JADWIN DAM

CONDITION REPORT

DAM, OUTLET WORKS & SPILLWAY

PERIODIC INSPECTION REPORT NO. 4

LACKAWAXEN RIVER BASIN
JADWIN DAM
DYBERRY CREEK, PENNSYLVANIA
INSTRUMENTATION PLAN

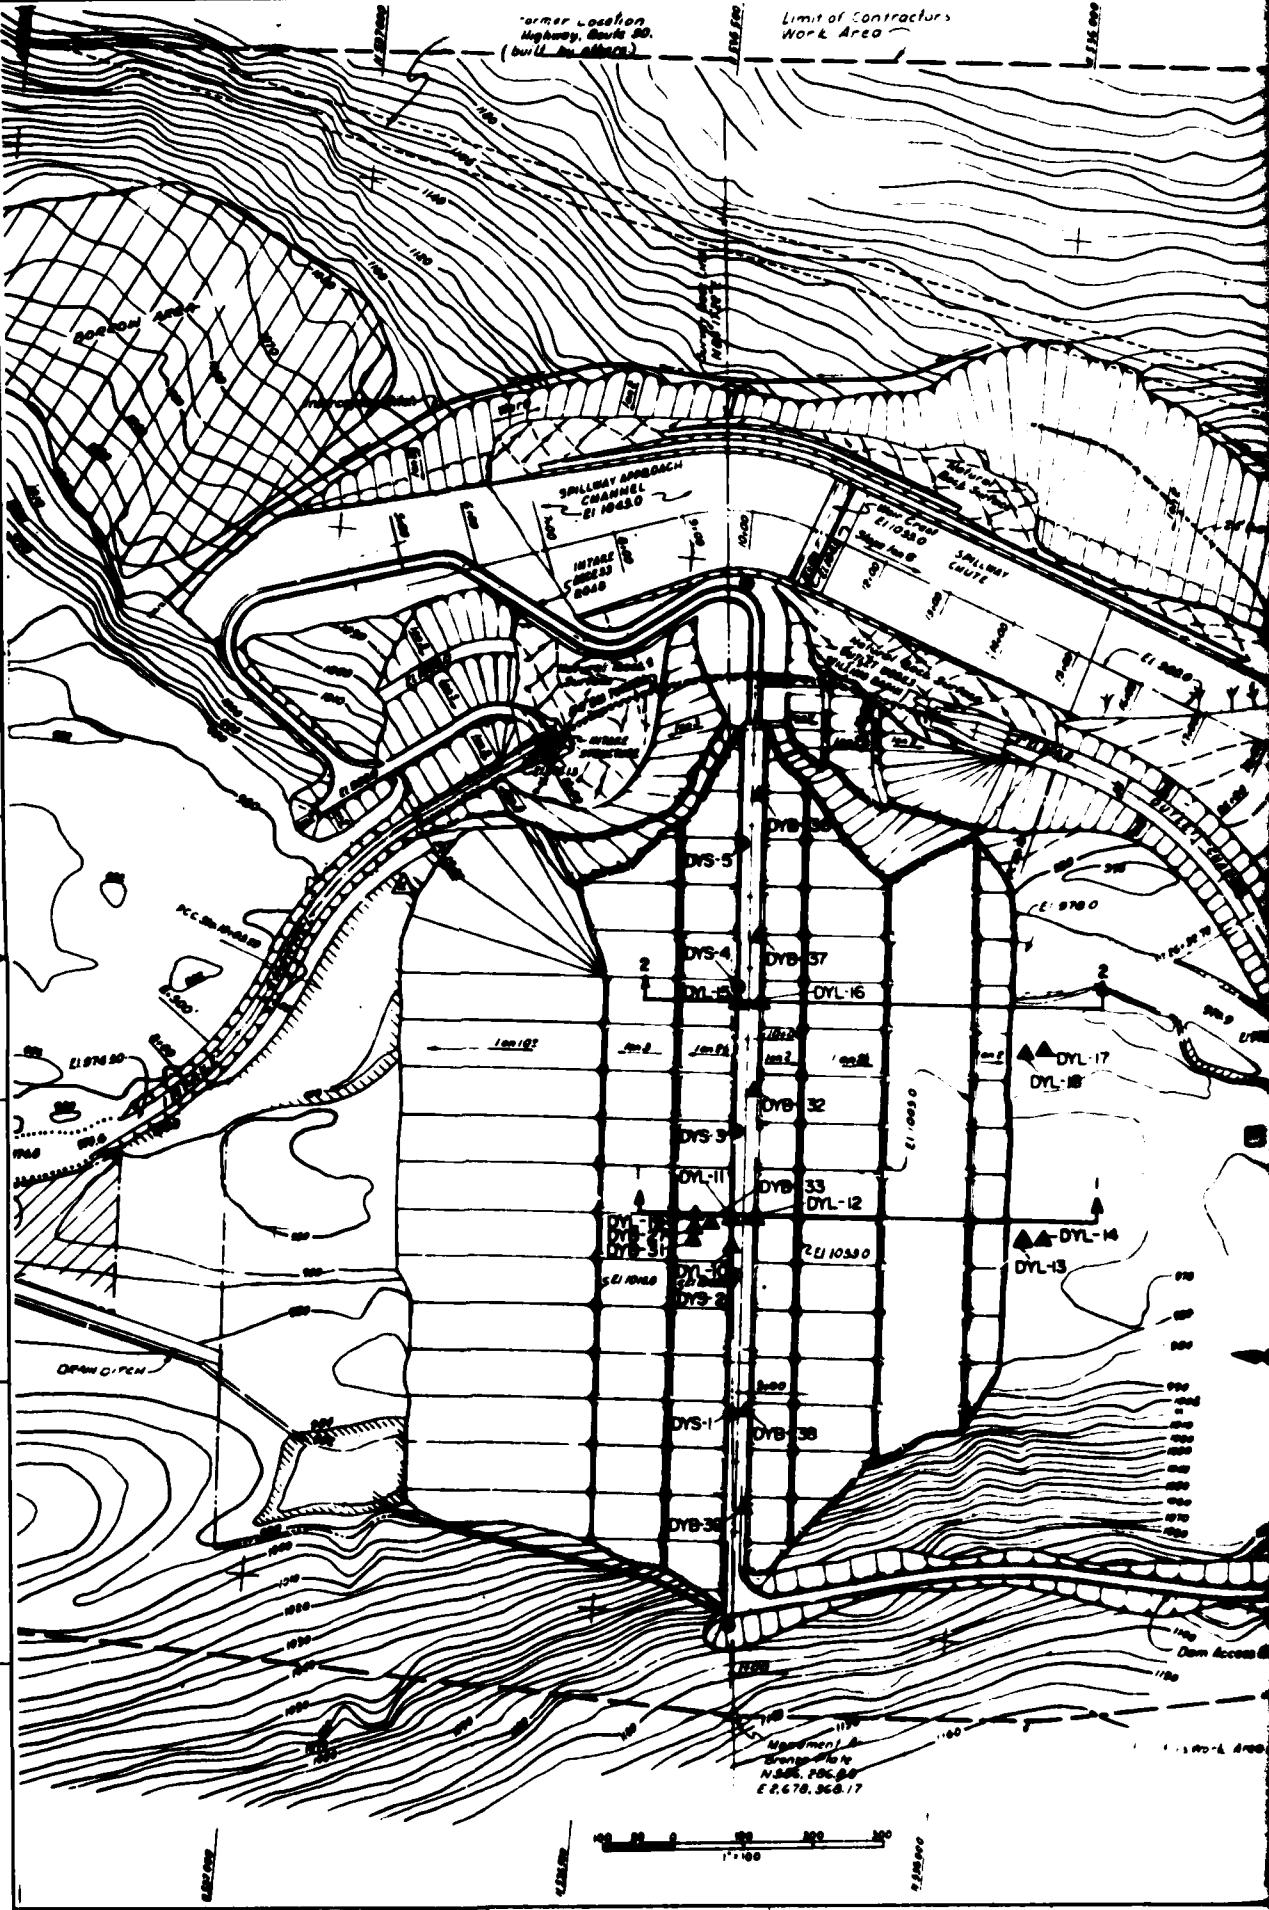
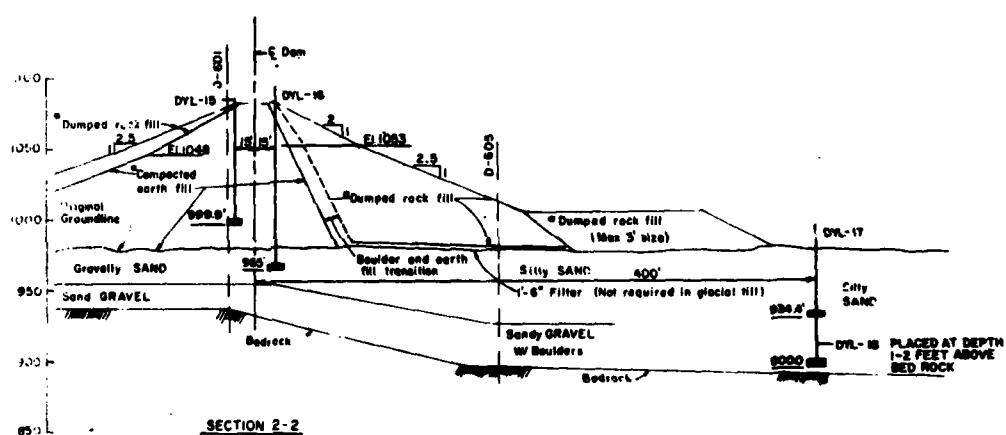
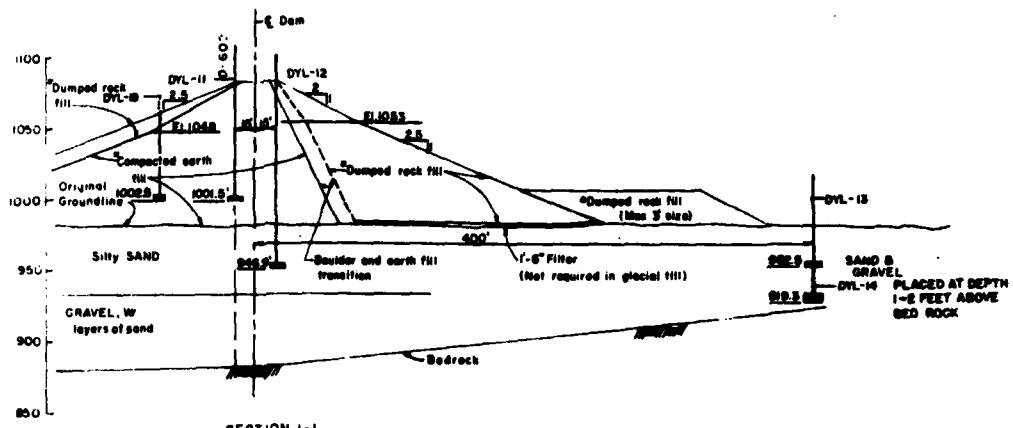
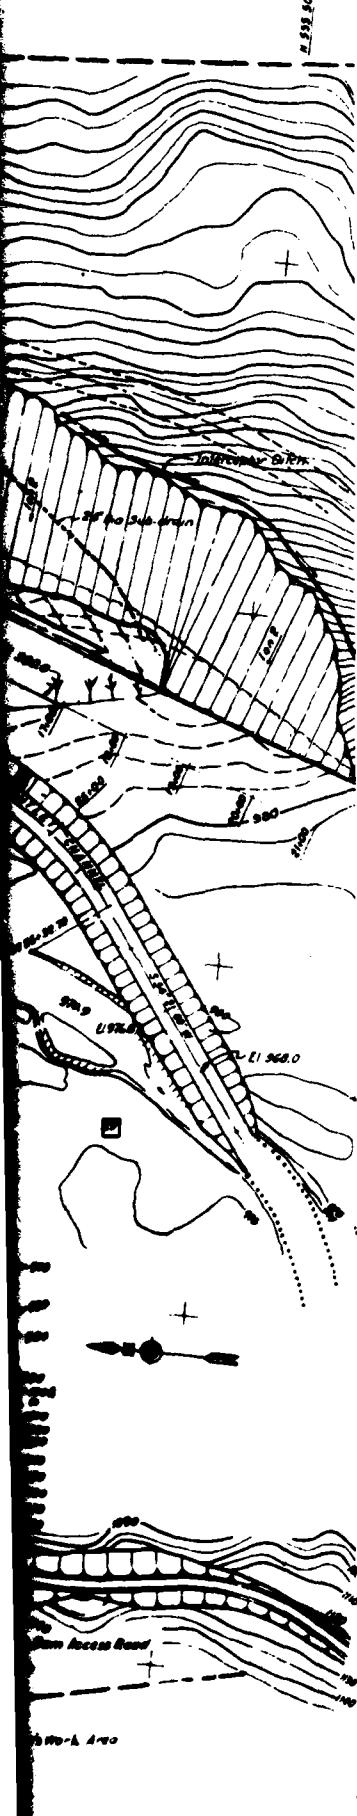
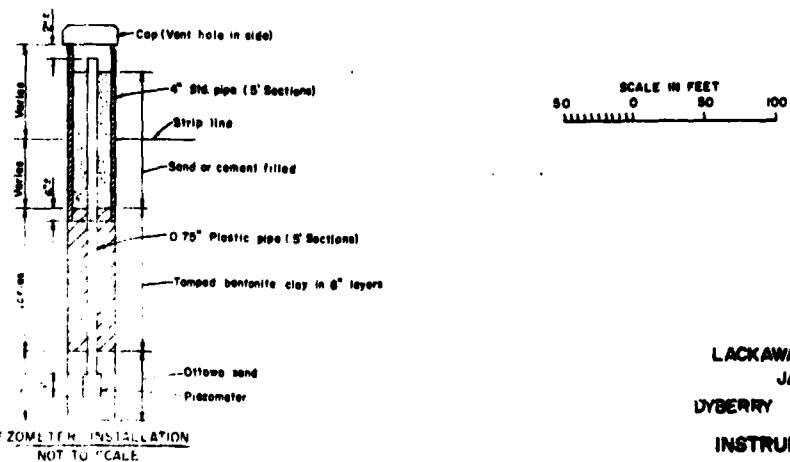
Review of piezometer data obtained prior to 1976 revealed questionable readings of piezometer DYB-19 in October and November 1974. Plate 1 has been revised to indicate the unreliability of those readings and has been included in this report for future reference.

Photo No. 9. Cracking in top of ogee weir.

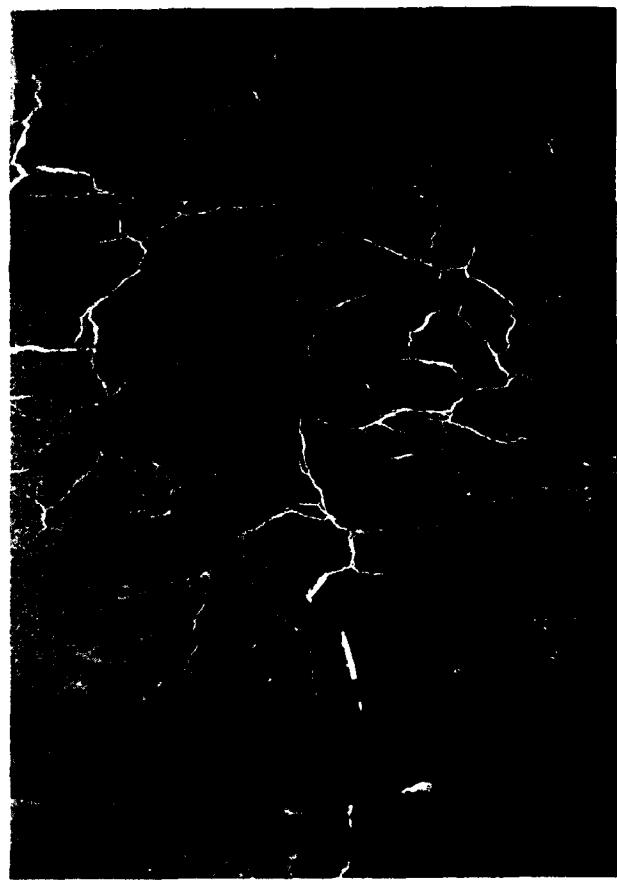
a. Weir. Considerable surface deterioration of concrete including cracking and spalling at the top and downstream portion of the ogee. Extensive cracking varying from hairline to $\frac{1}{8}$ inch width at top of the ogee noted. Recommend sealing of the wider cracks (larger than $\frac{1}{32}$ inch).

- c. The second monolith from the left (looking downstream) has experienced more substantial cracks in the crest which should be sealed as they will lead to substantial spalling of the crest (cracks generally run in a pattern which parallels the long axis of the weir).
